IEEE 802.3 dj Test Fixture Electrical Requirements

In Support of Comment 289 Against D2.0

Figure 179A-1

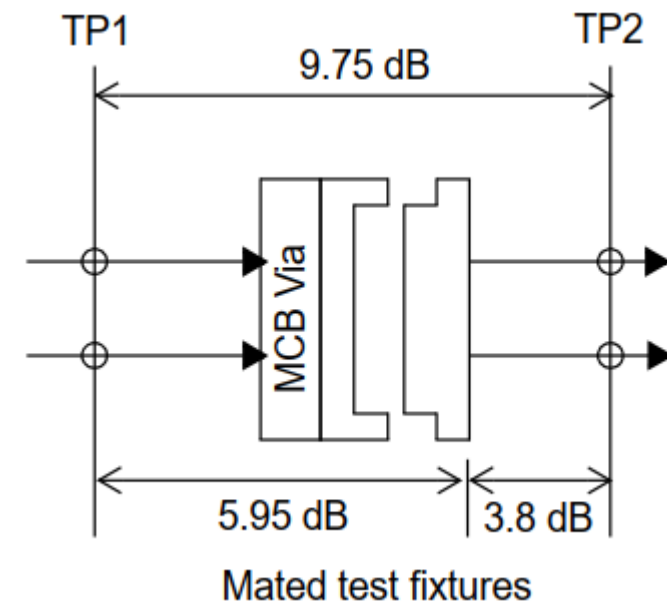
1. Add 2.7 dB informative reference back to what it was in Draft 1.4 (Figure 179A-1).
 1. This provides a loss target for MCB designers
2. Change 179B-2 to exclude the connector and only represent the test point and the transitional media up to the connector.
 1. Equation: $IL_{catfref} = -0.0067f^{1.5} + 0.0309f - 0.2523\sqrt{f} + 0.0868$
 2. This provides a loss target for MCB designers
 3. This reference plane can be directly verified in measurement.
3. HCBs and MCBs are validated using 2x-thrus and equations 179B-1 and 179B-2
4. The connector on the MCB is validated using the mated test fixtures.

179B.3.1 Cable assembly test fixture insertion loss

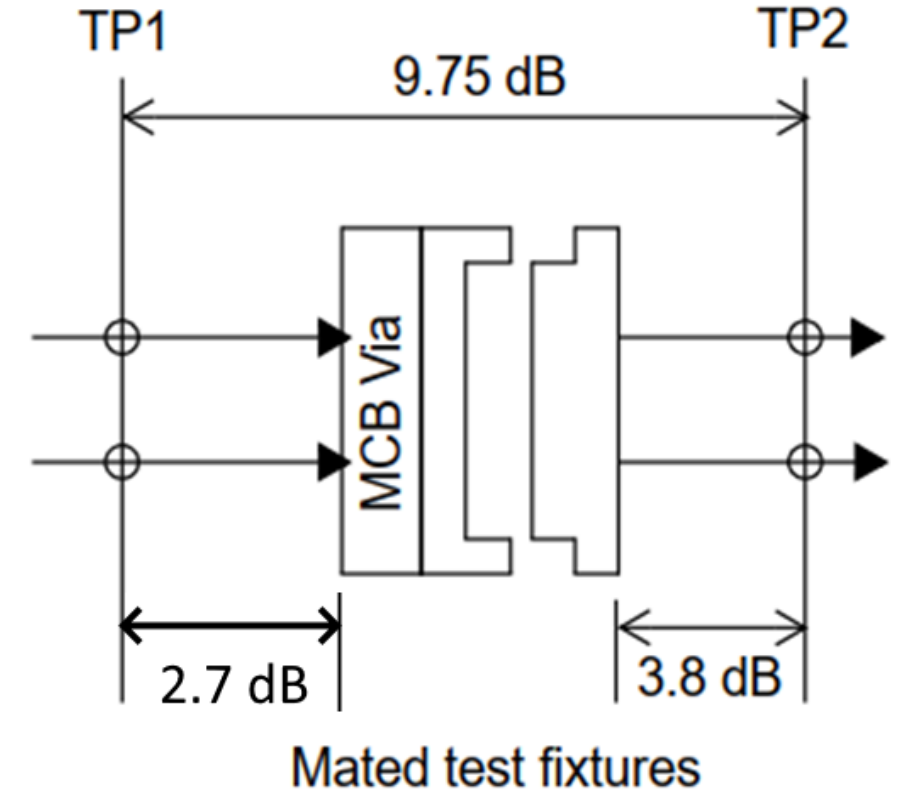
1. We need to independently validate/verify the MCB and HCB.

2. MCBs cannot be validated on their own.

1. Equation 179B-2 which governs MCBs cannot be verified directly, because test points do not and cannot exist at the current reference plane. The open-circuit test have too much noise.
2. If we cannot validate their performance, we cannot “account for the difference”
3. Since MCBs cannot be validated on their own, non-compliant HCBs could pass based on the mated test fixture requirement.

Demonstrate the MCB measurement problem

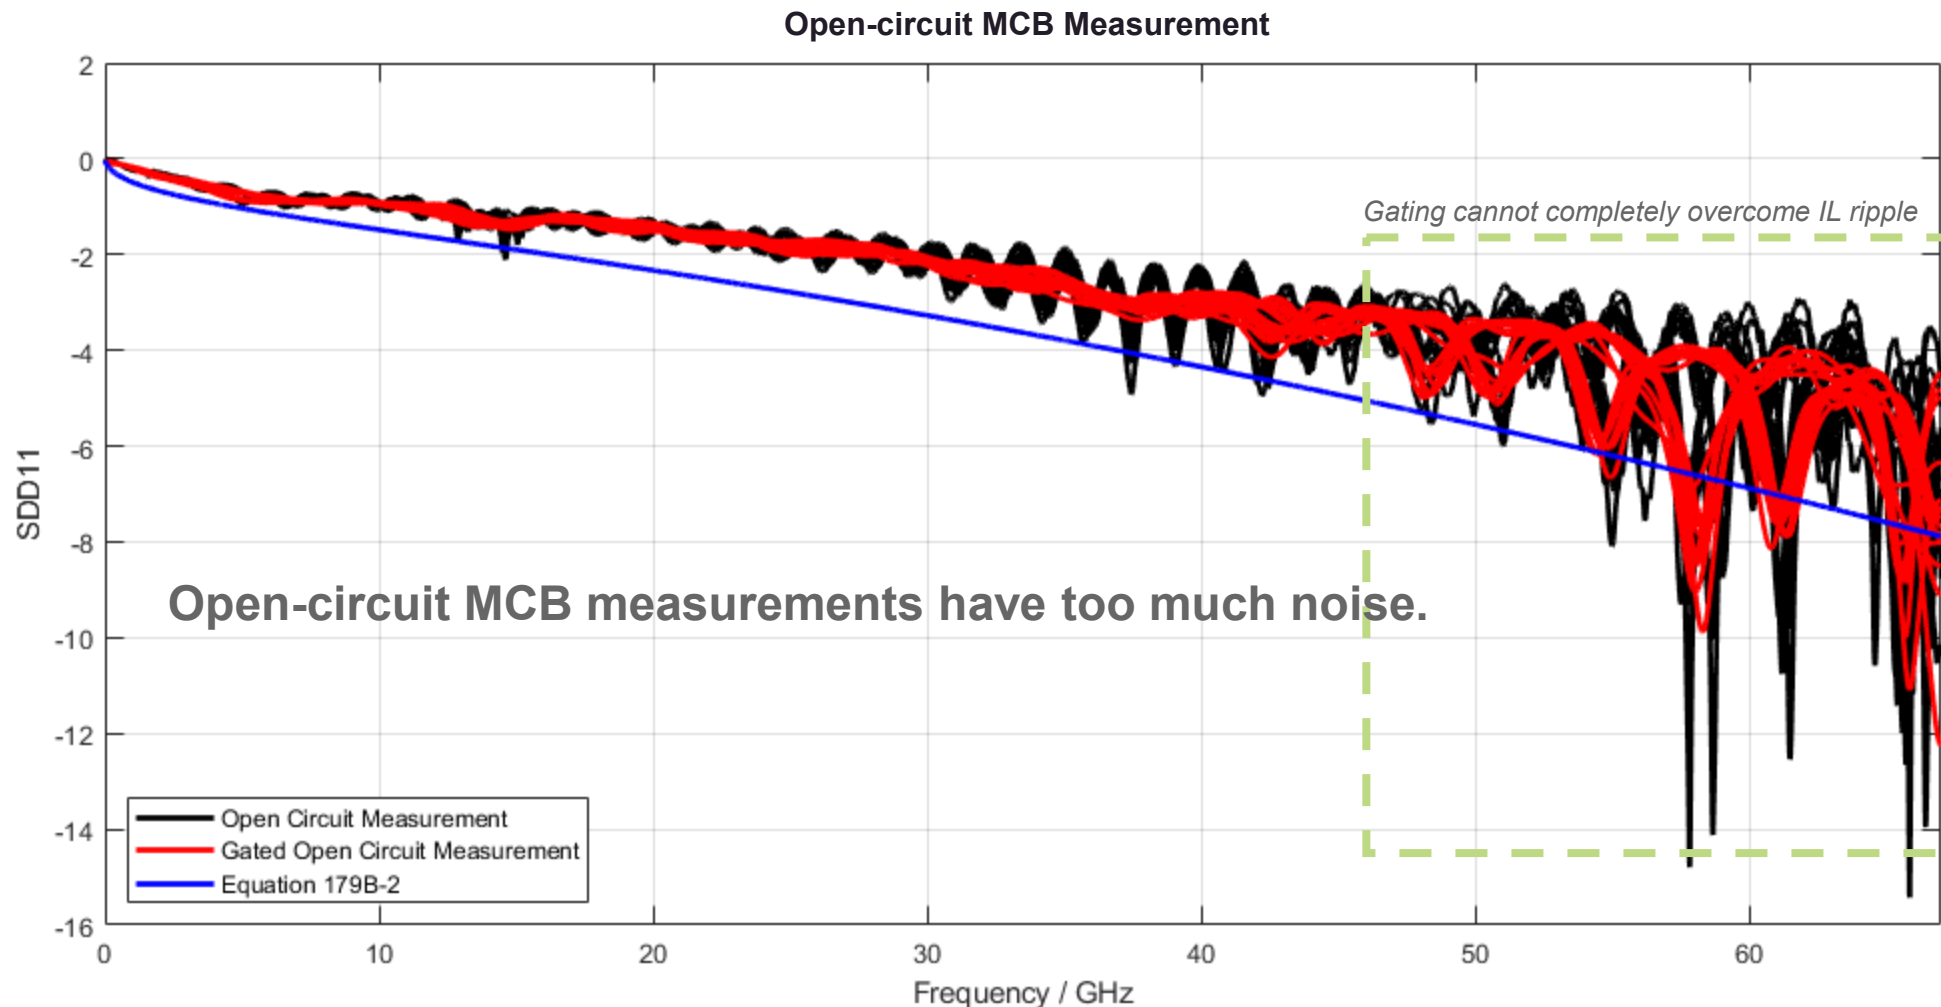
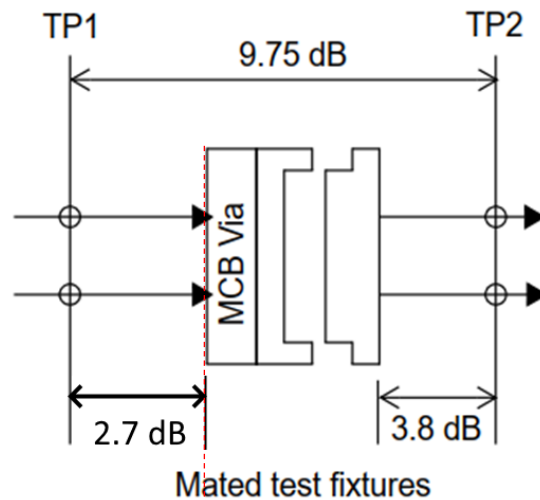
Low loss MCBs could allow non-compliant HCBs to pass the MTF limits without accounting for the difference between MCB loss and Equation 179B-2. Non-compliant HCBs would over-stress transmitters

2x-thru/2 Vs. Proposed Reference Line

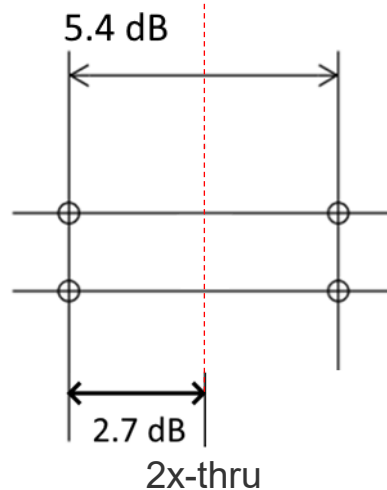
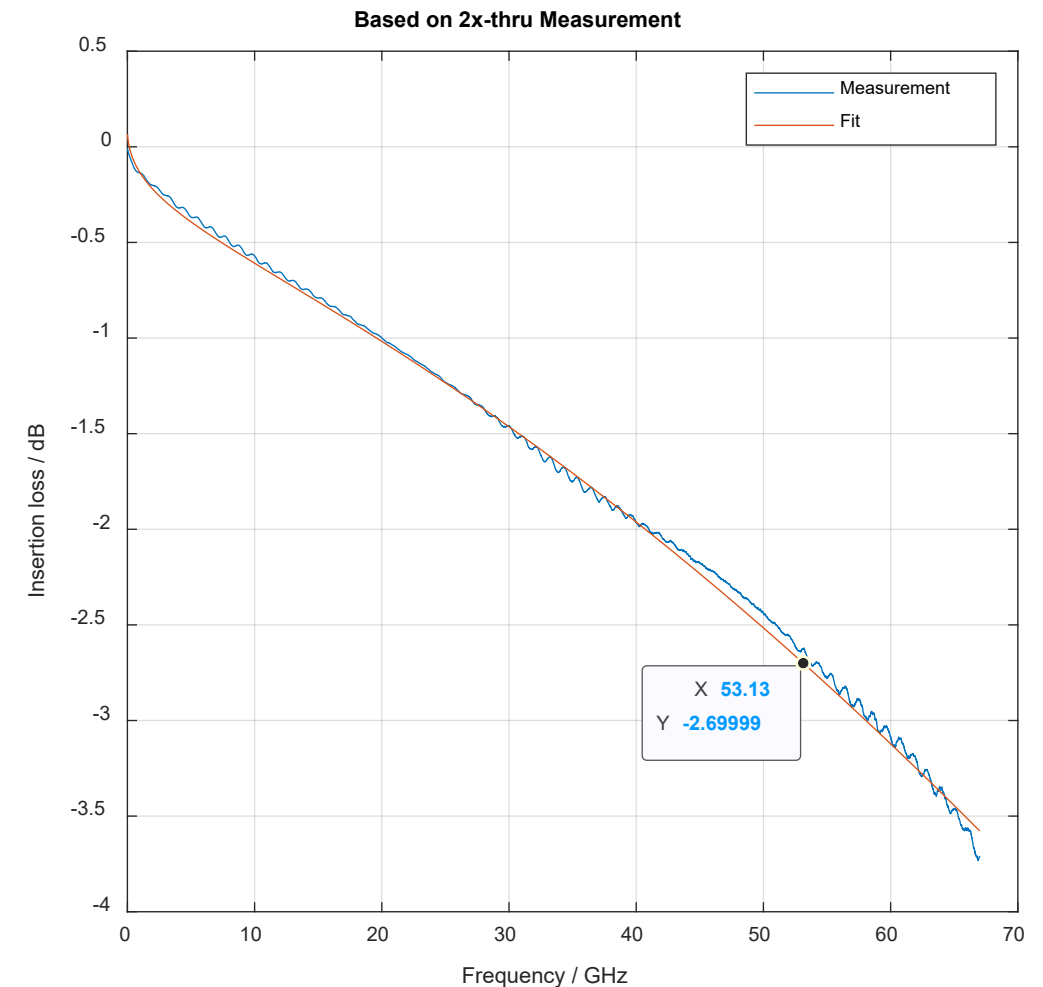
$$IL_{catfref} = -0.0067f^{1.5} + 0.0309f - 0.2523\sqrt{f} + 0.0868$$
